WEST SUSSEX COUNTY COUNCIL CONSULTATION

TO:	Mid Sussex District Council FAO: Steve King
FROM:	WSCC – Highways Authority
DATE:	15 April 2026
LOCATION:	Land At Hurst Farm Hurstwood Lane Haywards Heath West Sussex
SUBJECT:	DM/26/0682 Reserved Matters Application Pursuant to Outline Planning Permission Mid Sussex District Council (MSDC) Reference: DM/25/1630, Lewes District Council (LDC) Reference: LW/2510707 at Hurst Farm, for appearance, layout, scale and landscaping only.
RECOMMENDATION:	More Information

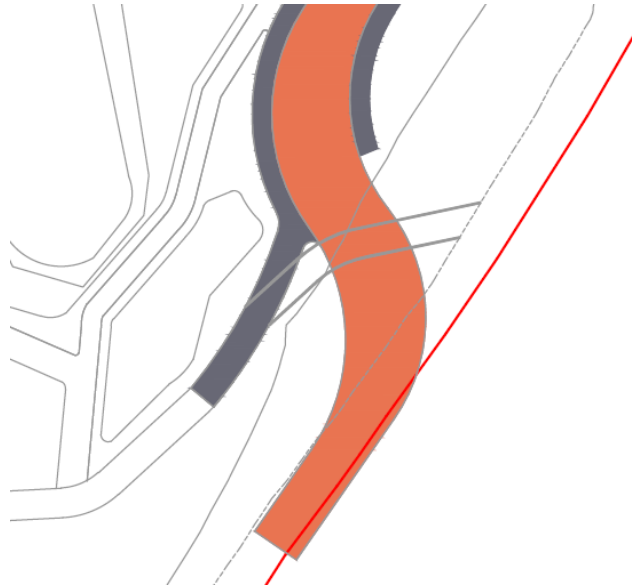
11. The only comment would be in respects of clarification over the feature crossing the access road in the vicinity of the initial access into the site. The

Adoption Plan appears to show a footway or similar crossing the access road and then joining Hurstwood Lane, a snip of this is shown below.

12. This feature is not then continued on the Landscape Strategy.

13. WSCC Highways would endorse the provision of a footway link as implied on the Adoption Plan. This then would provide a means for pedestrians and cyclists to join Hurstwood Lane that is to be closed to vehicular traffic as part of this development.
